Review Assessment

Port Fourchon Belle Pass Channel Deepening  
Project

Section 203 Feasibility Study  
(January 2019, revised January 2020)

**April 2020**

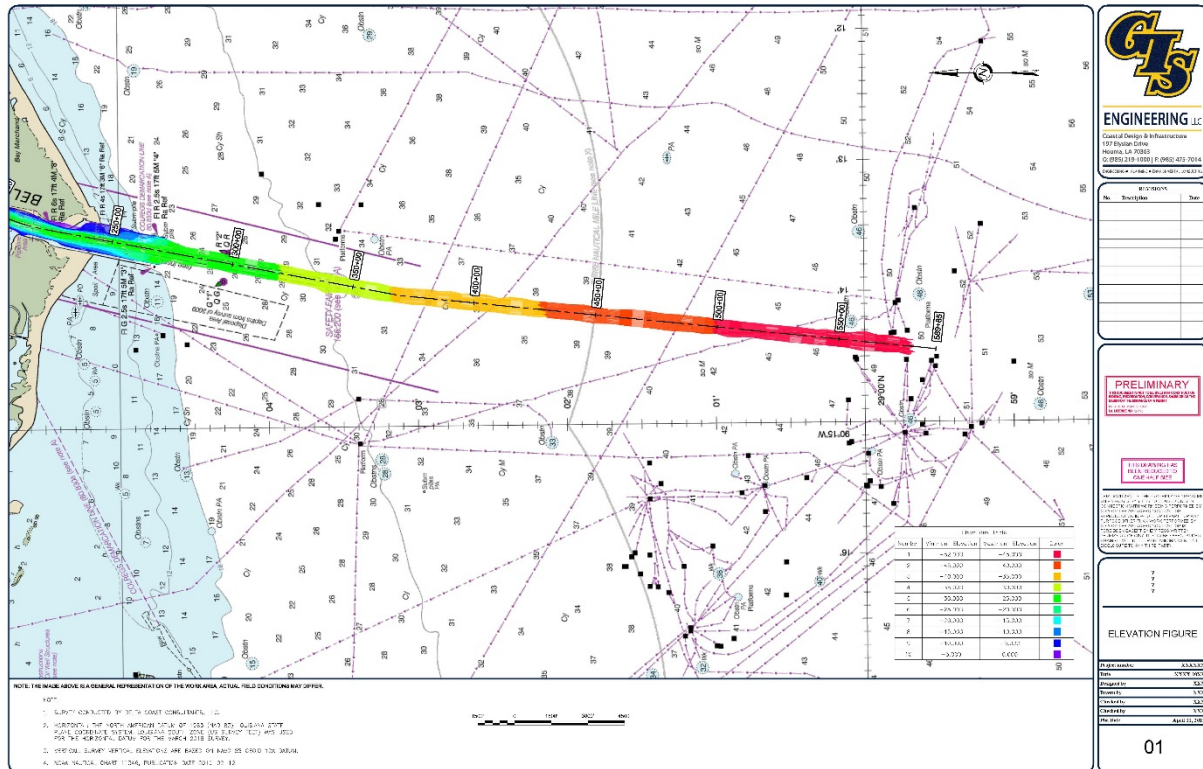
1. Channel Depth Distance from Port: From a review of an NOAA navigation chart of the area, it appears the proposed deepened 50-foot channel ends in 30-foot deep waters. It appears the existing 41 mile channel would need to be extended approximately 5 additional miles to reach 50-foot plus depths. It is unclear if this extension is part of the project and project costs.

Basis of concern: Project costs may not be adequately reflected

Significance of concern. High as it relates to project justification
